ELMIRA NORTH - SITE PLAN WITH ADJUSTMENT

ELMIRA NORTH - SITE PLAN
WITH ADJUSTMENT
2525 N. ELMIRA STREET AURORA, CO 80010

SITE PLAN

1 PROPOSED SITE PLAN
1" = 20'-0"

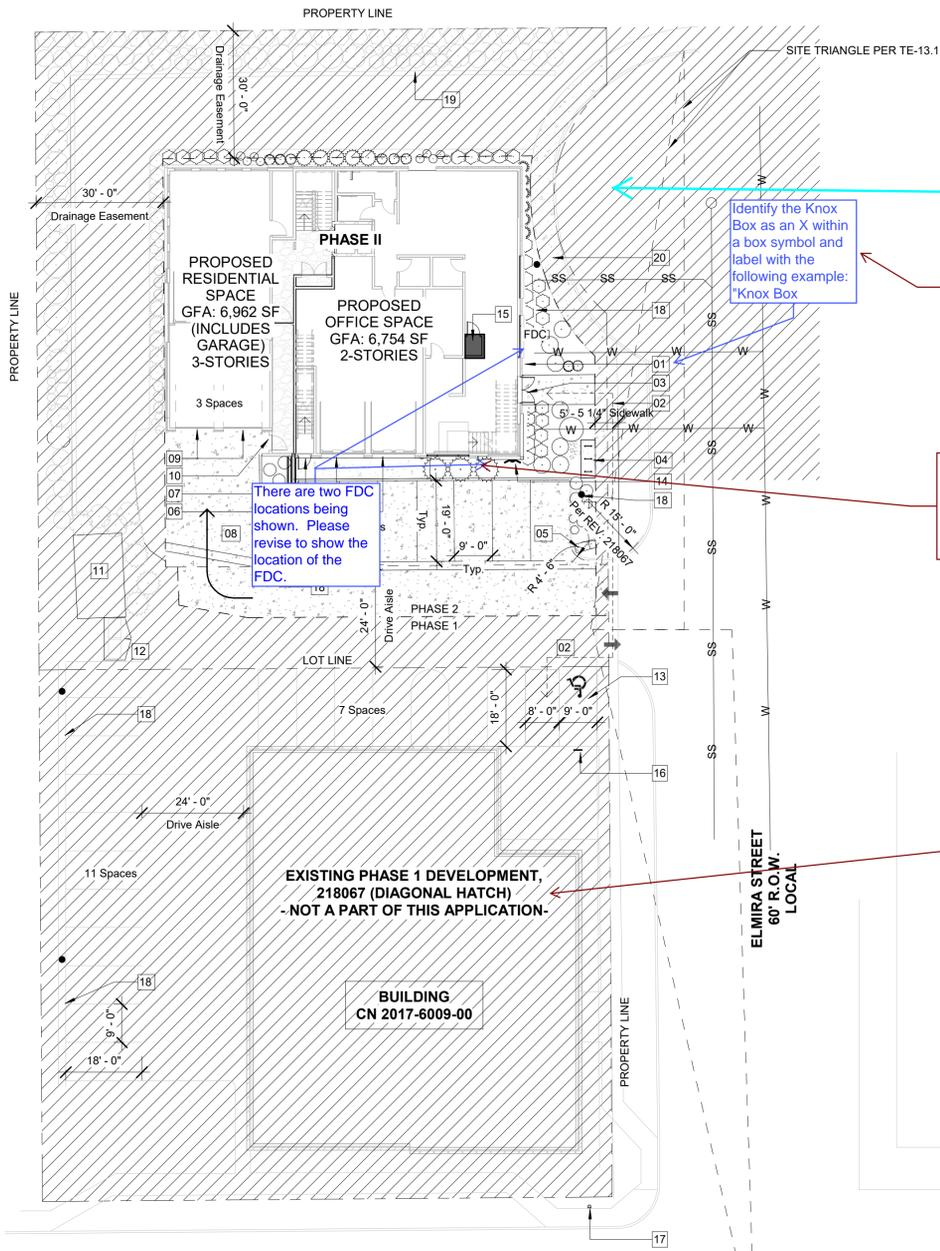
The site plan will not be approved by public works until the preliminary drainage letter/report is approved

Why is this hatched? Is this part of Phase 2?

Identify the Knox Box as an X within a box symbol and label with the following example: "Knox Box"

FACTOR RESPONSE: UNDERSTOOD

FACTOR RESPONSE: KNOX BOX HAS BEEN NOTED - SEE KEYNOTE 14

FACTOR RESPONSE: SOUTHERN MOST FDC LOCATION HAS BEEN REMOVED

FACTOR RESPONSE: CUL-DE-SAC WILL BE REPAVED AS PART OF PHASE 1

ADA PARKING
N.T.S.

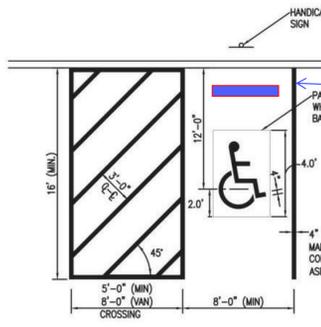
Provide a curb block for any stalls with posted signage

FACTOR RESPONSE: CURB BLOCK HAS BEEN ADDED TO DETAIL

GRADING PLAN

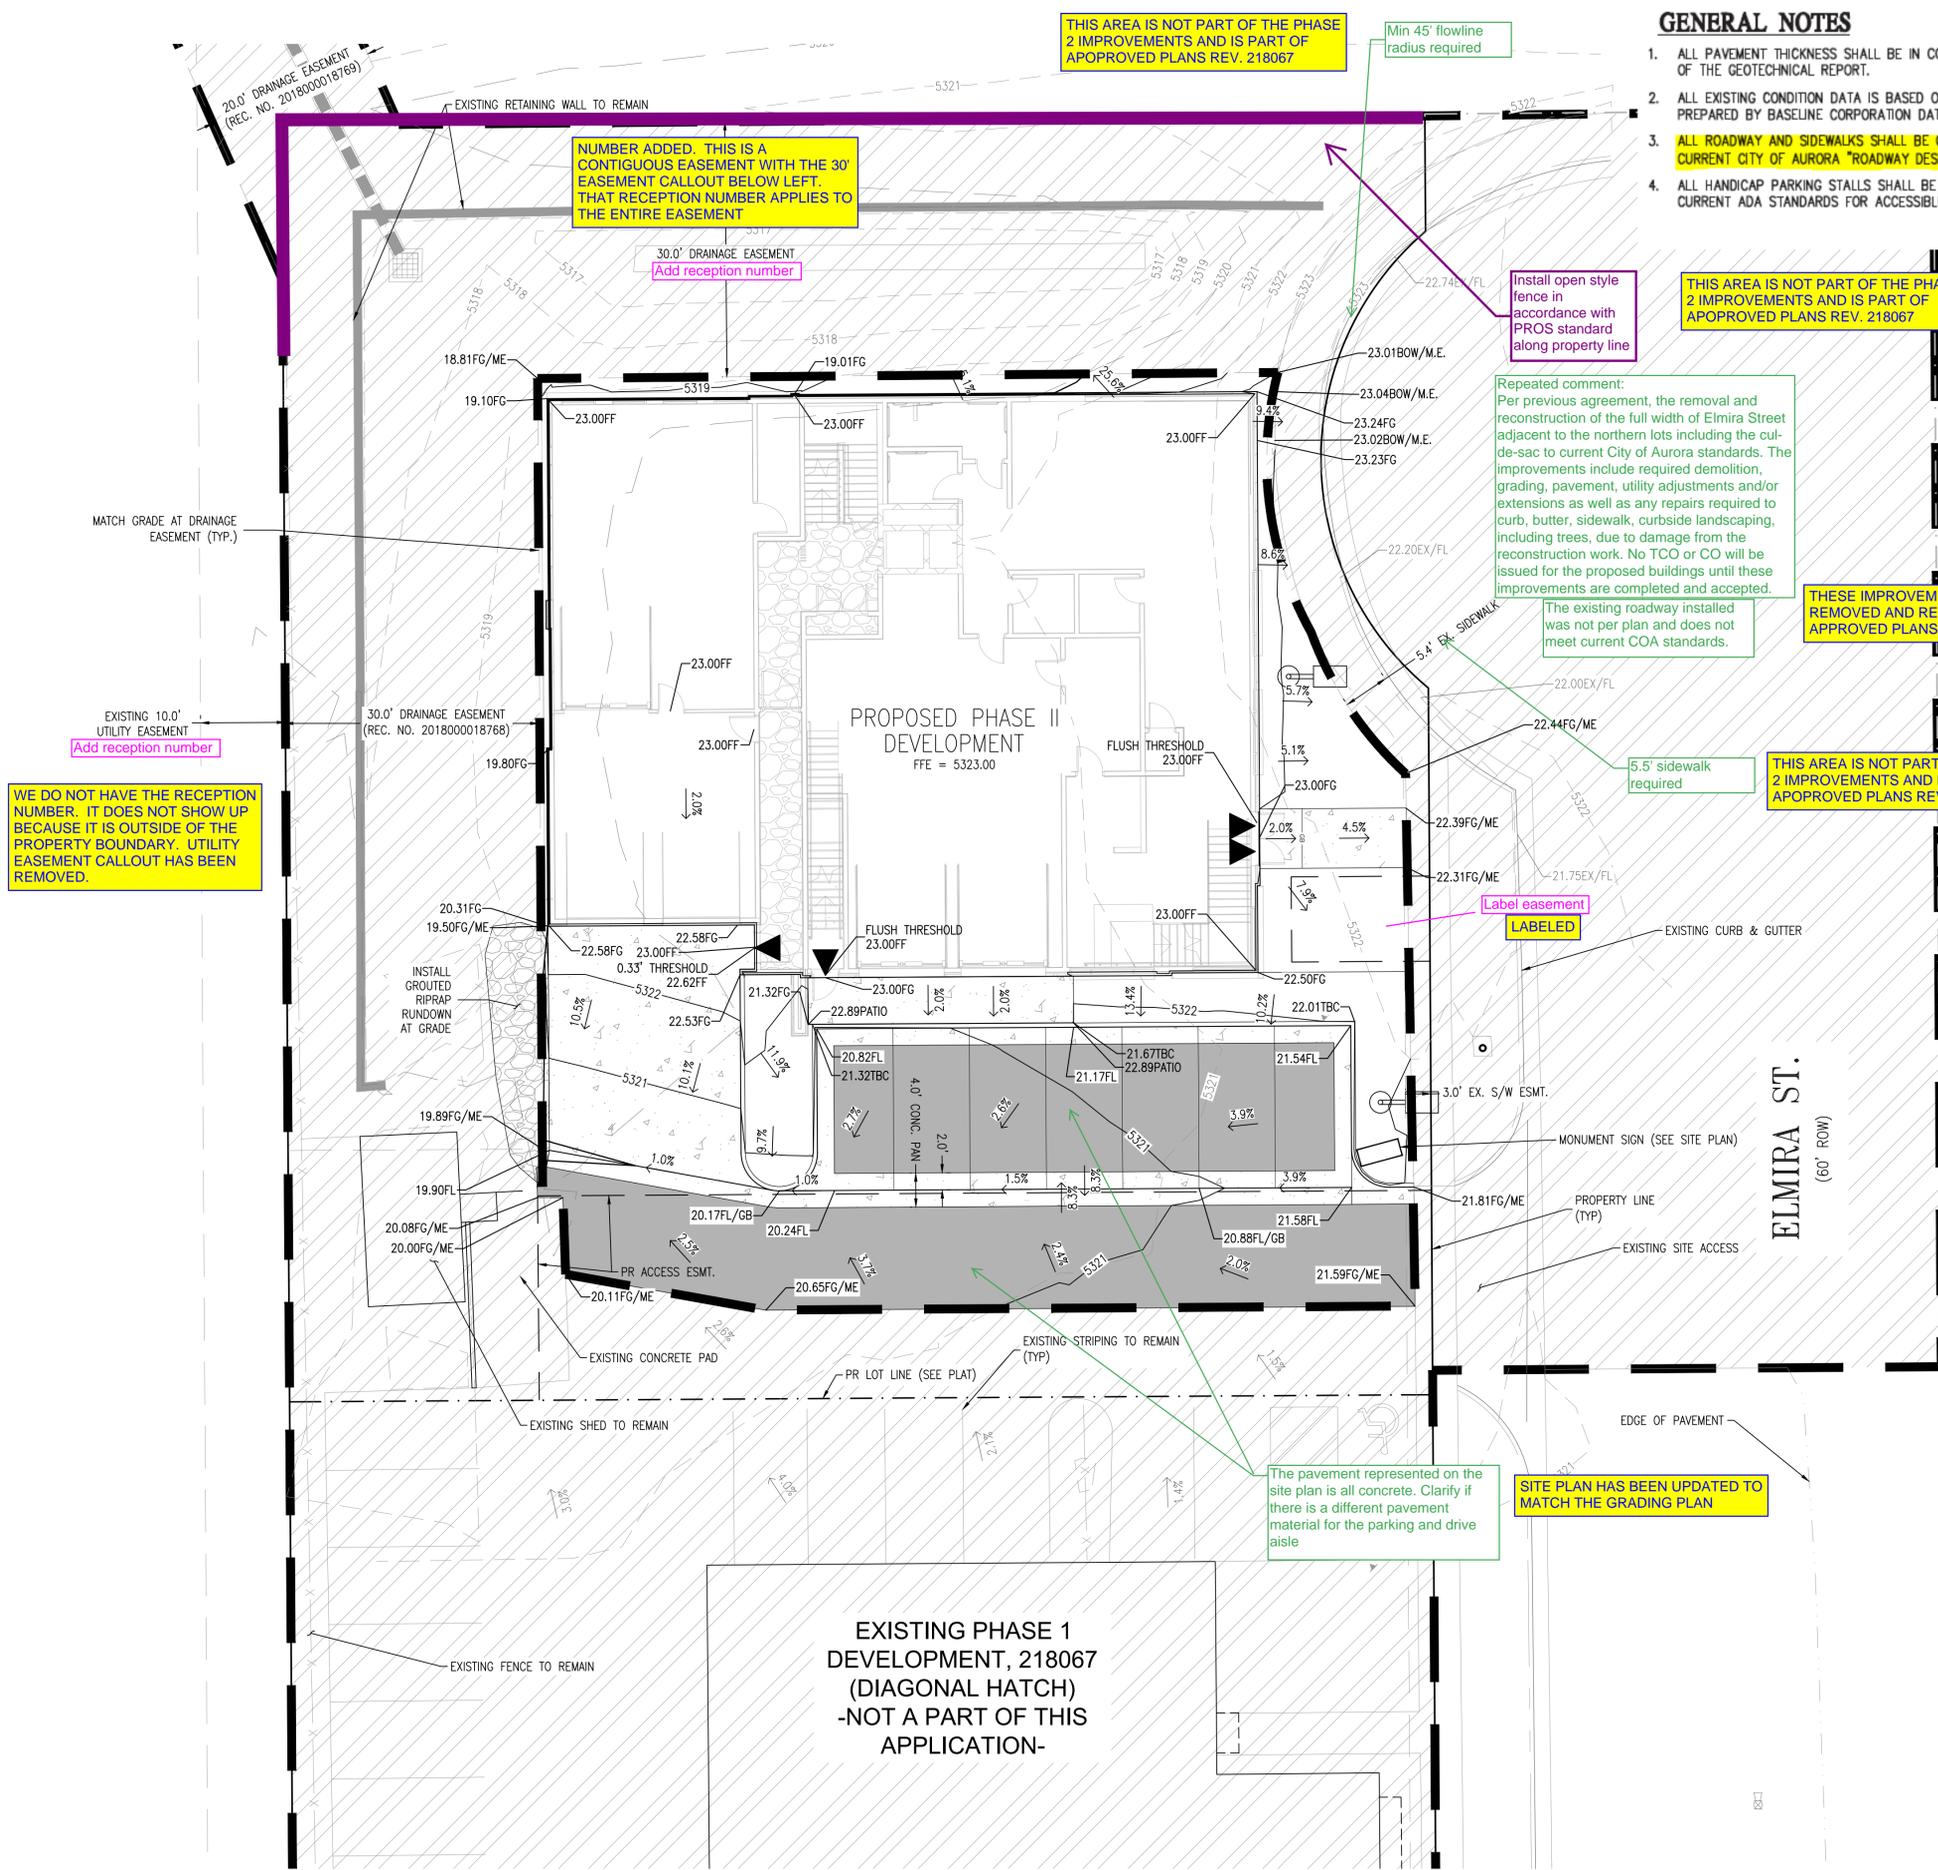
Repeated comment: Per previous agreement, the removal and reconstruction of the full width of Elmira Street adjacent to the northern lots including the cul-de-sac to current City of Aurora standards. The improvements include required demolition, grading, pavement, utility adjustments and/or extensions as well as any repairs required to curb, gutter, sidewalk, curbside landscaping, including trees, due to damage from the reconstruction work. No TCO or CO will be issued for the proposed buildings until these improvements are completed and accepted.

The pavement represented on the site plan is all concrete. Clarify if there is a different pavement material for the parking and drive aisle

THIS AREA IS NOT PART OF THE PHASE 2 IMPROVEMENTS AND IS PART OF APROVED PLANS REV. 218067

NUMBER ADDED. THIS IS A CONTIGUOUS EASEMENT WITH THE 30' EASEMENT CALLOUT BELOW LEFT. THAT RECEPTION NUMBER APPLIES TO THE ENTIRE EASEMENT

THESE IMPROVEMENTS WILL BE REMOVED AND REINSTALLED PER THE APPROVED PLANS.

SITE PLAN HAS BEEN UPDATED TO MATCH THE GRADING PLAN

UTILITY PLAN

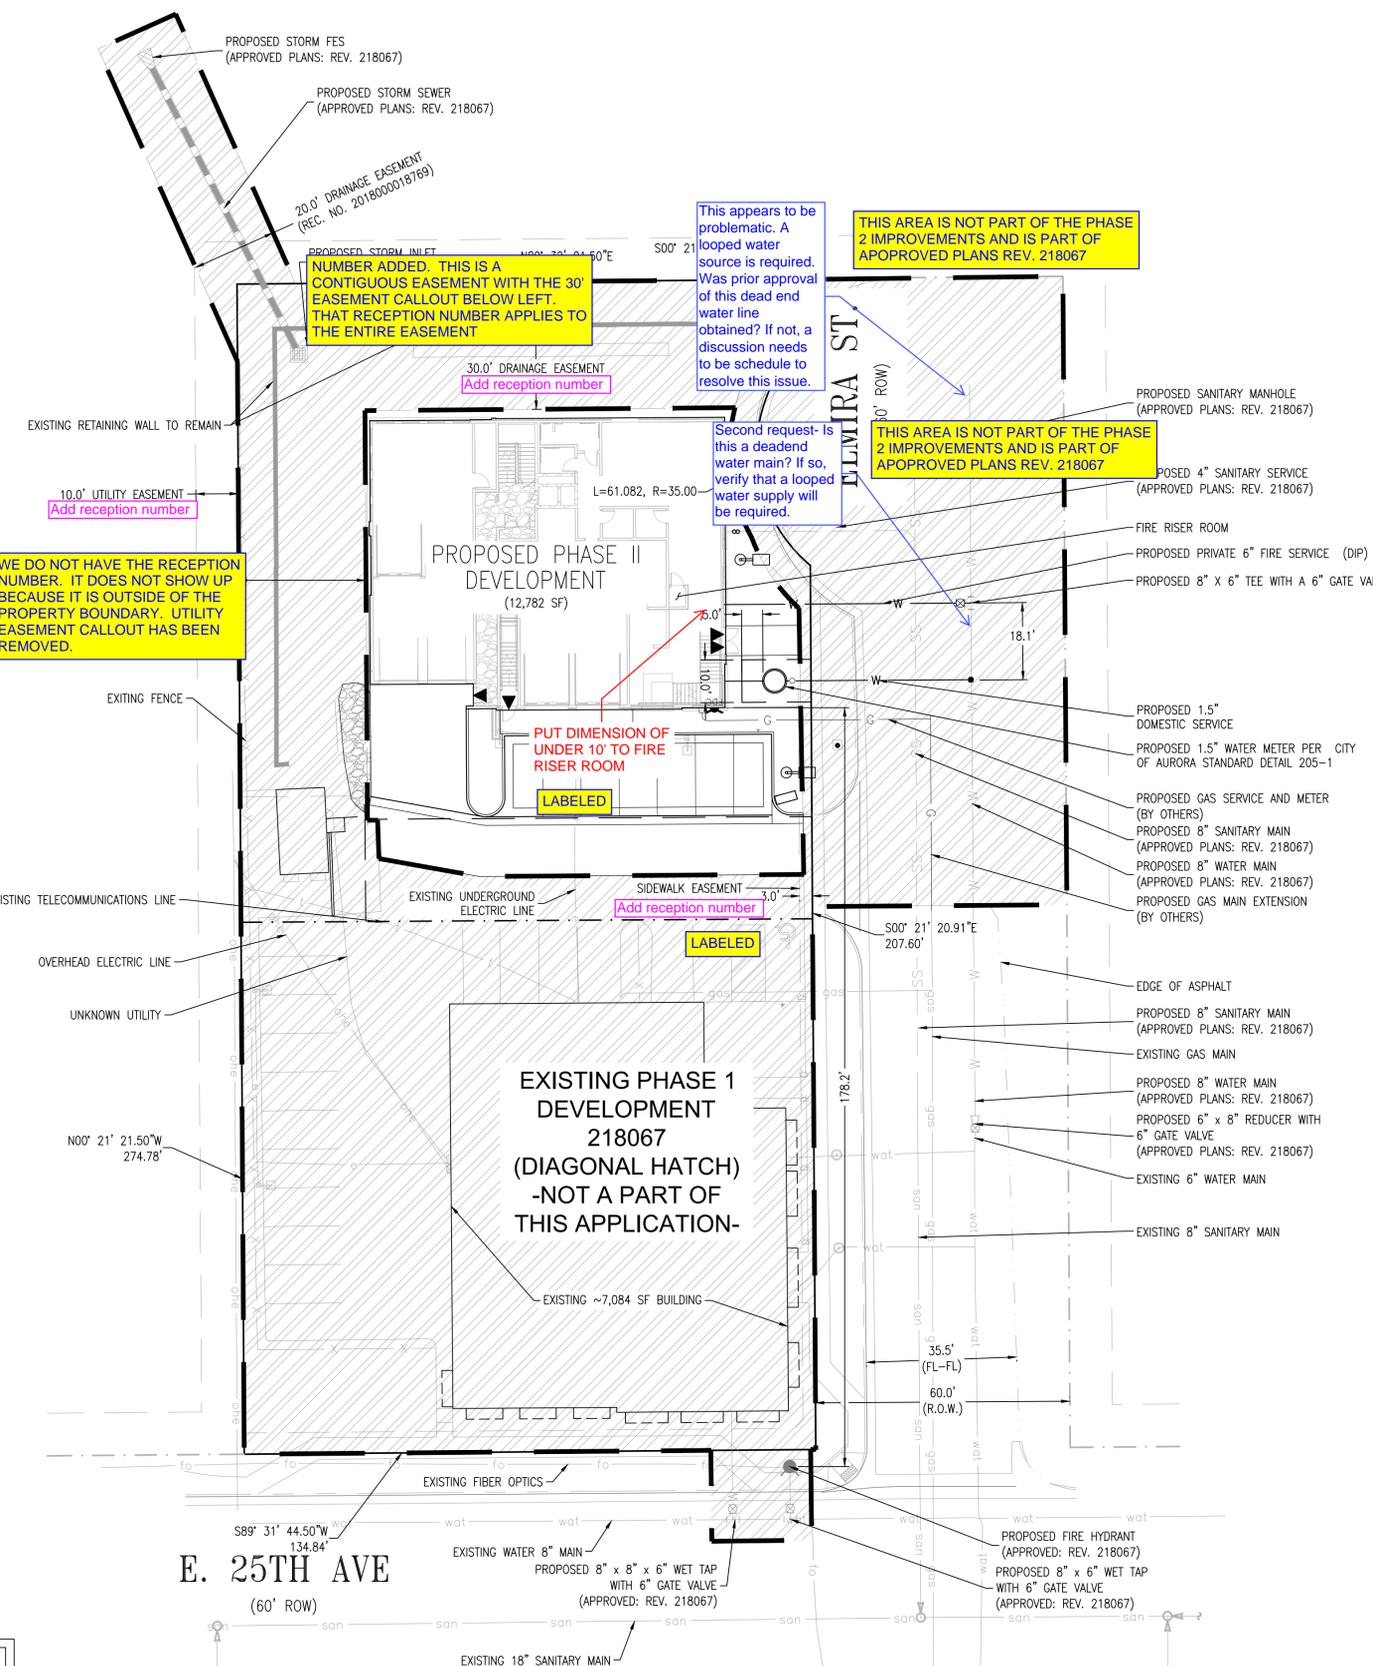
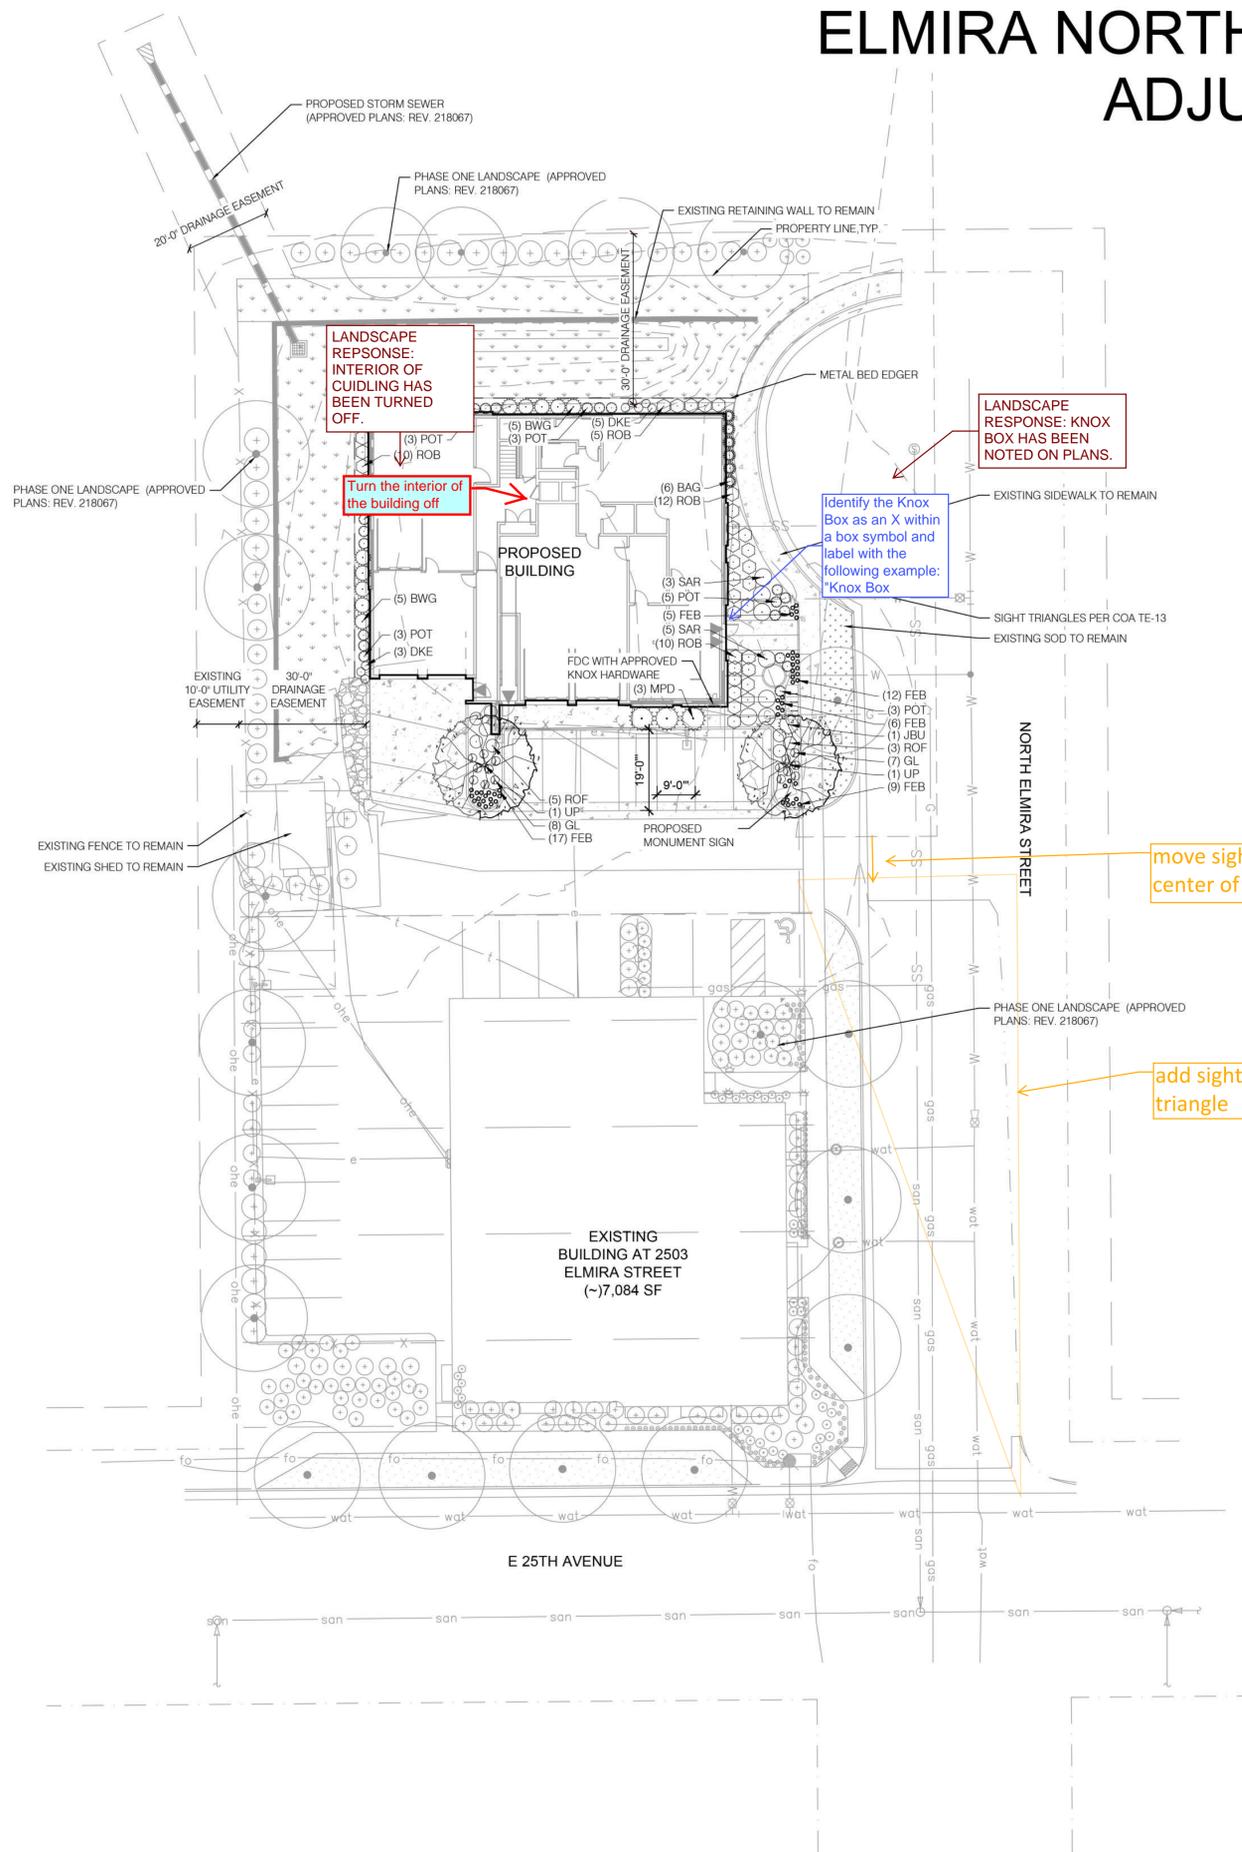
This appears to be problematic. A looped water source is required. Was prior approval of this dead end water line obtained? If not, a discussion needs to be schedule to resolve this issue.

Second request- Is this a deadend water main? If so, verify that a looped water supply will be required.

WE DO NOT HAVE THE RECEPTION NUMBER. IT DOES NOT SHOW UP BECAUSE IT IS OUTSIDE OF THE PROPERTY BOUNDARY. UTILITY EASEMENT CALLOUT HAS BEEN REMOVED.

NUMBER ADDED. THIS IS A CONTIGUOUS EASEMENT WITH THE 30' EASEMENT CALLOUT BELOW LEFT. THAT RECEPTION NUMBER APPLIES TO THE ENTIRE EASEMENT

THIS AREA IS NOT PART OF THE PHASE 2 IMPROVEMENTS AND IS PART OF APROVED PLANS REV. 218067

THIS AREA IS NOT PART OF THE PHASE 2 IMPROVEMENTS AND IS PART OF APROVED PLANS REV. 218067

LANDSCAPE PLAN

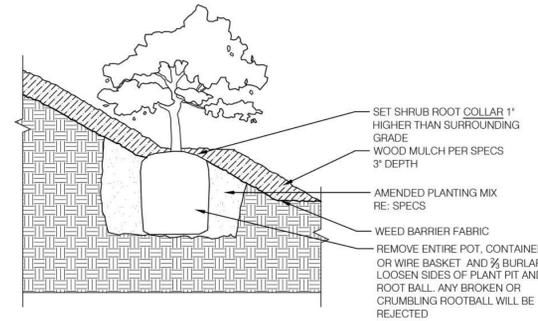
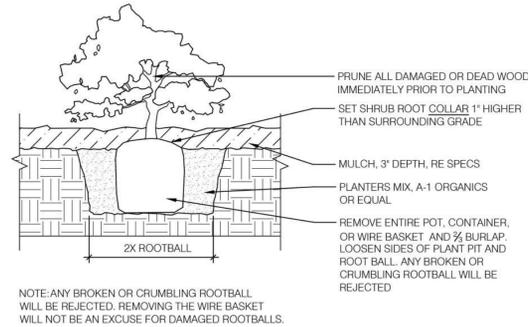
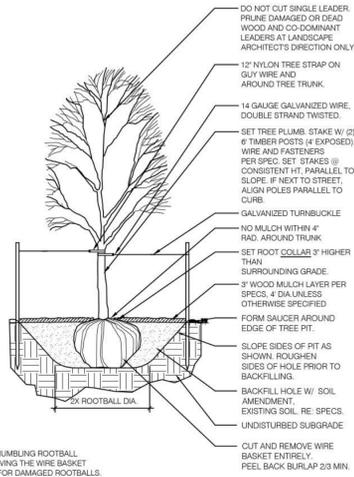
While a nice evergreen shrub, these do not perform well here.

Identify the Knox Box as an X within a box symbol and label with the following example: "Knox Box"

Turn the interior of the building off

Label as Building Perimeter Landscape Table

Add the following Fire Life Safety landscape note:
LANDSCAPE MATERIAL SHALL NOT BE PLACED OR KEPT NEAR FIRE HYDRANTS IN A MANNER THAT WOULD PREVENT SUCH EQUIPMENT FROM BEING IMMEDIATELY DISCERNIBLE. A 5-FOOT CLEAR SPACE SHALL BE MAINTAINED AROUND THE CIRCUMFERENCE OF FIRE HYDRANTS. LANDSCAPING MATERIAL SHOWN WITHIN THE SITE PLAN CANNOT ENCROACH INTO ROADWAYS THAT ARE DEDICATED (OR DESIGNATED) AS FIRE LANE EASEMENTS (OR CORRIDORS).

LANDSCAPE REPOSENSE: SEE UPDATED SPEC WITH NEW SHRUB

LANDSCAPE REPOSENSE: KNOX BOX HAS BEEN NOTED ON PLANS.

LANDSCAPE REPOSENSE: INTERIOR OF CUIDLING HAS BEEN TURNED OFF.

LANDSCAPE REPOSENSE: TABLE HAS BEEN LABLED AS REQUESTED.

LANDSCAPE REPOSENSE: COUNT HAS BEEN UPDATED

LANDSCAPE REPOSENSE: ADDITIONAL LANDCAPE NOTES HAVE BEEN ADDED TO DRAWING SET.
